Access Compliance Report Public Rights-of-Way (Curb Ramps)

Intersection ID: 12711 Main Street: W STONEWALL ST Cross Street: S_TRYON_ST Location: W

Overall Compliance: No ADA ID: 4EBC8F982DFE Ramp Type: Perp Initial Pass/Fail: Pass **Severity Score:** 7.5

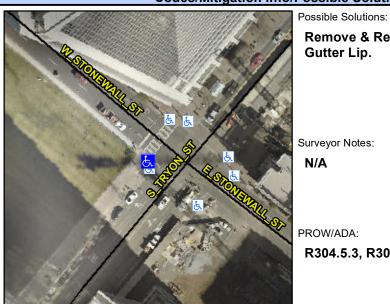
Street 1 Name Stop Condition-Street 2 Street 2 Name Stop Condition-Street 1 Remove & Replace Landing. Grind Gutter Lip.

R304.5.3, R302.7.2
